MPC8306S Chip Errata

This document details all known silicon errata for the MPC8306S. The following table provides a revision history for this document.

Figure 1. Recommended connections for DDR controller and memory

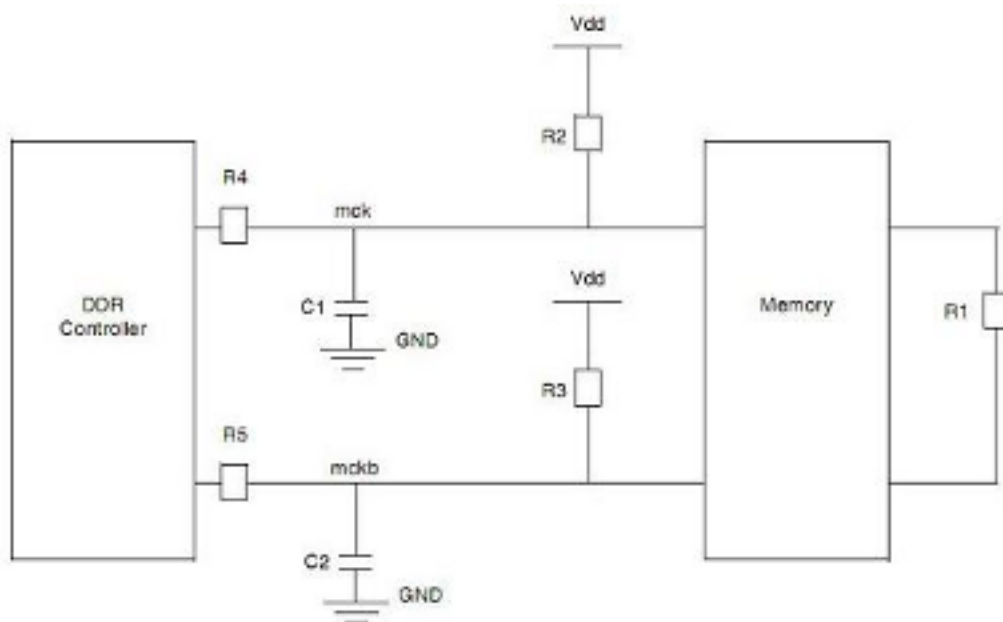
DDR21: MCK/ $\overline{\text{MCK}}$ AC differential crosspoint voltage outside JEDEC specifications

Description: The crossover points of the MCK and $\overline{\text{MCK}}$ signals of the DDR controller are not meeting JESD79-2C specifications, which indicates that the crossover points should lie within ± 125 mV range of reference voltage.

Workaround: To meet the JESD79-2C crosspoint voltage specifications, we recommend implementing the following connections between the DDR controller and DDR2 memory:

1. Increasing R2 and R3 shifts signal levels up (used as pull up).
2. Increasing C1 increases rise/fall time of mck signal.
3. Increasing C2 increases rise/fall time of mckb signal.
4. Reducing R1 can help in shifting the signals up.
5. R4 and R5 can be used to make termination proper.

R4, R5, C1, C2 near to SOC, R1, R2, and R3 have been placed at the end of clock transmission lines.

We recommend varying termination resistor R1 first. Lowering R1 can help increase the voltage levels up. The only disadvantage is that it may add up more reflections. Therefore, the user must decide accordingly. If it does not give sufficient margin, the user can add the pull-up resistor (R3 and R4) option to further increase the voltage levels.
